BID ADDENDUM 4 – DSA ADDENDUM NO. 11 DATE: 10/16/2026

PROJECT:
SANGER EDUCATION COMPLEX – PHASE 3b
Development of Building L, associated site development work and Alternate Bid 1
1850 S. Fowler Ave, Fresno, CA 93727

DARDEN PROJECT NO. 2171.L
DSA APPL. NO. 02-120779

L/M401.4
AD11

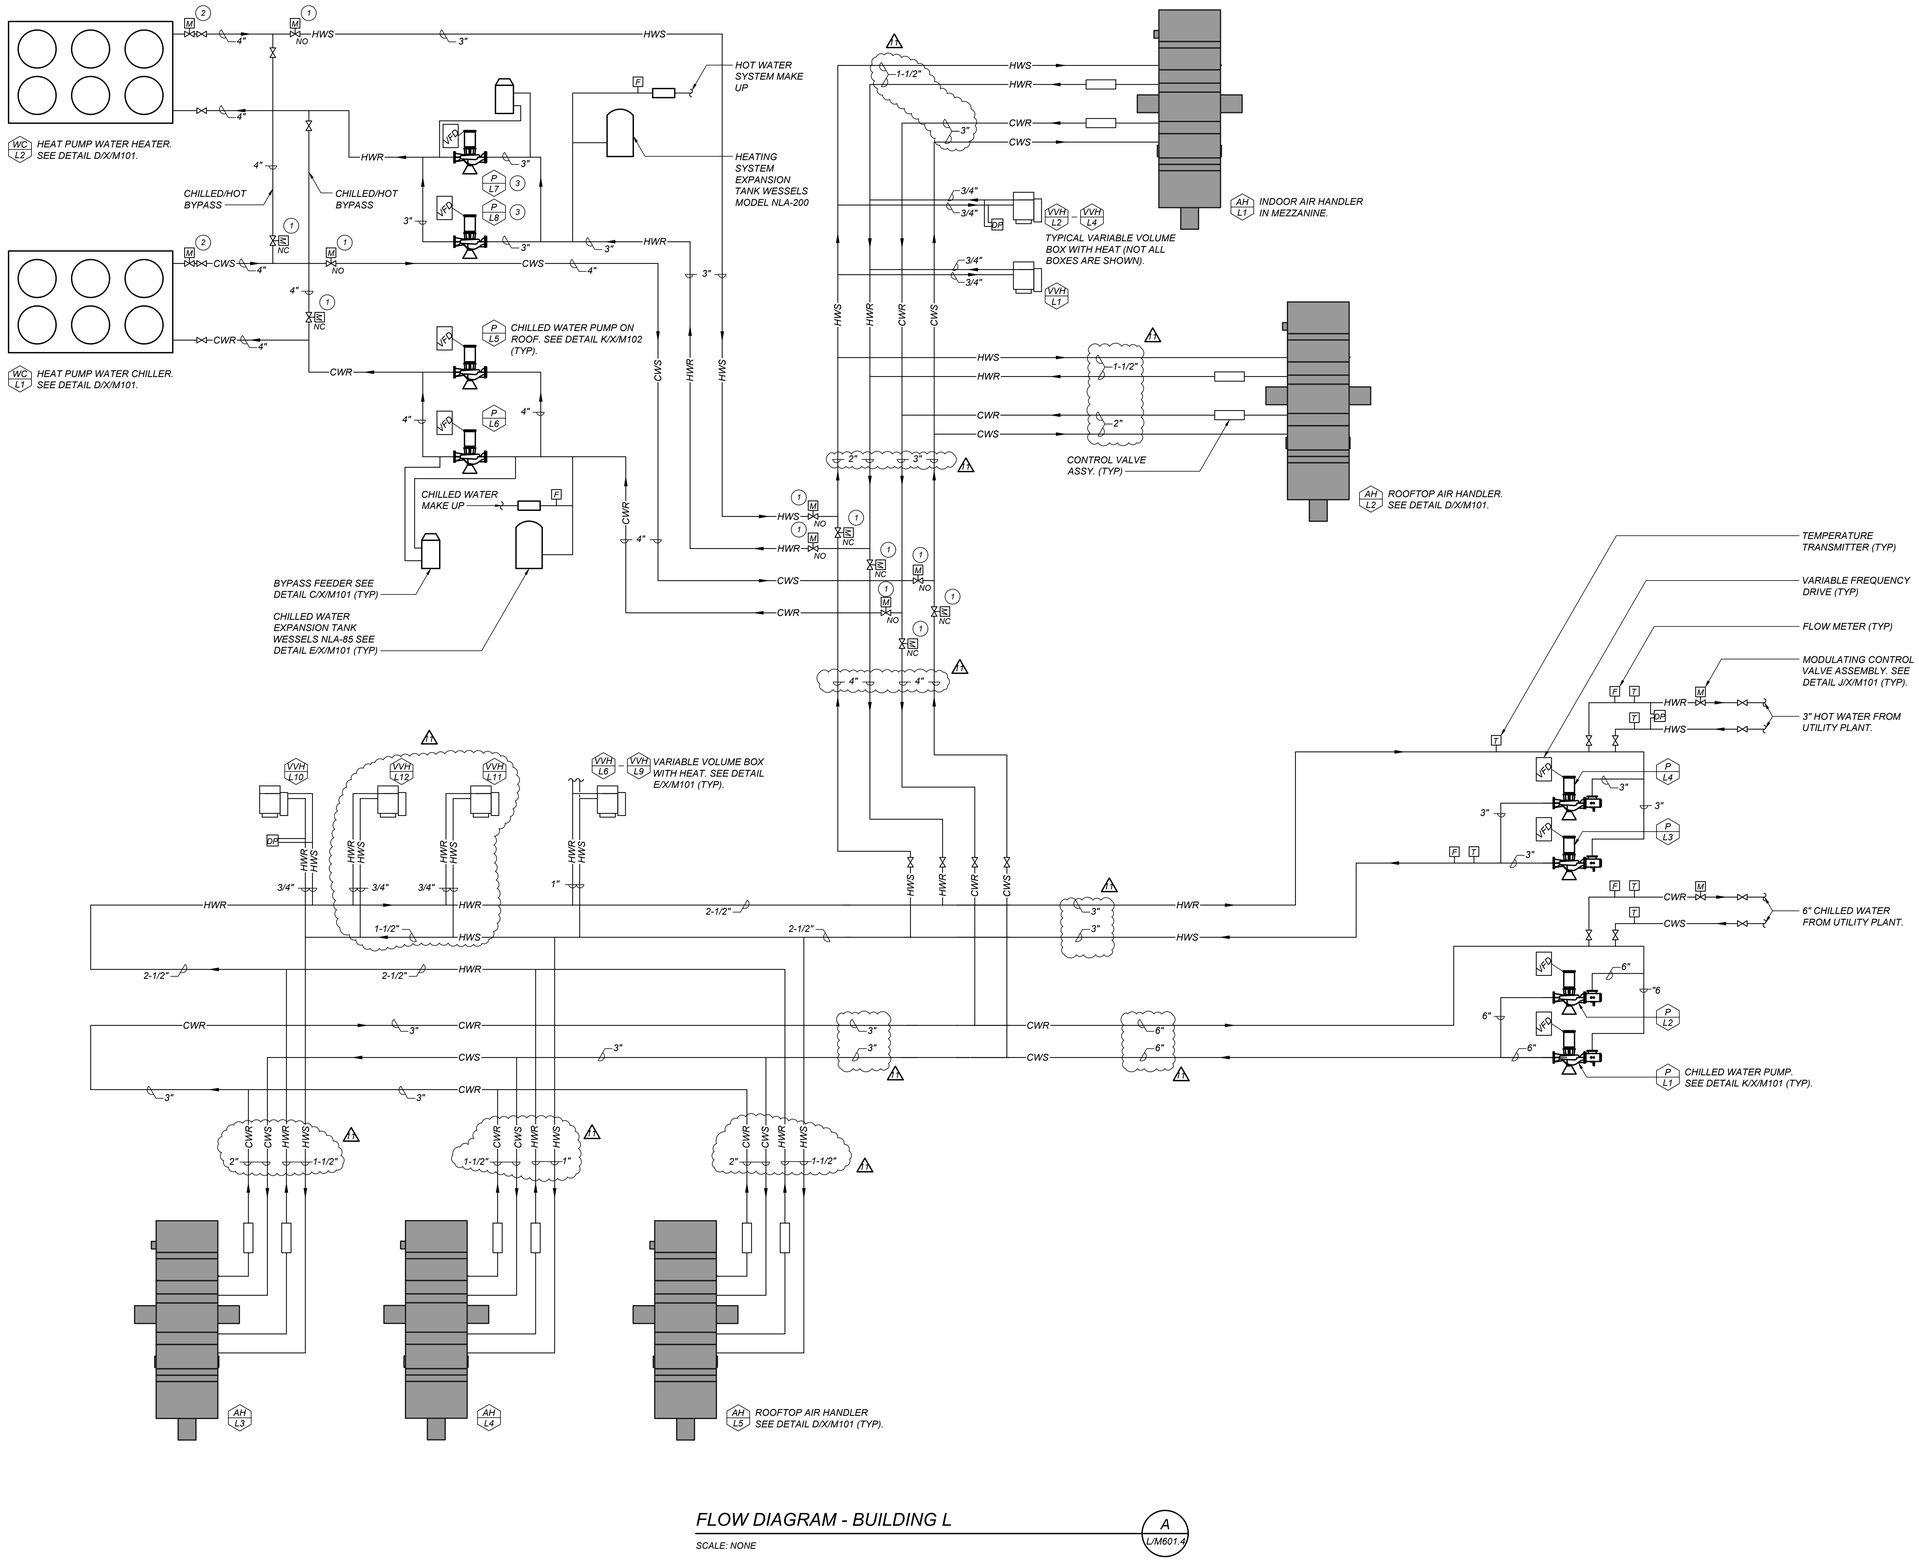
AD11-M02 Refer to Sheet L/M401.4

1. Provide an outside air intake hood and a relief air discharge hood at the locations indicated on Drawing L/M401.4 at grid lines L11 and LD.

2. The basis of design shall be Greenheck Models FGI and FGR, complete with curb cap and birdscreen.
3. Throat sizes shall be as indicated on Sheet L/M401.4. Refer to Detail A-X/M102 in this Addendum. Include all required accessories and appurtenances necessary for a complete and operational installation. Manufacturer and model information for the intake and relief hoods is provided herein as the basis of design.
4. Provide ROOF ACCESSORIES, Manufactured Equipment Curbs. See Detail E7-X/A508.
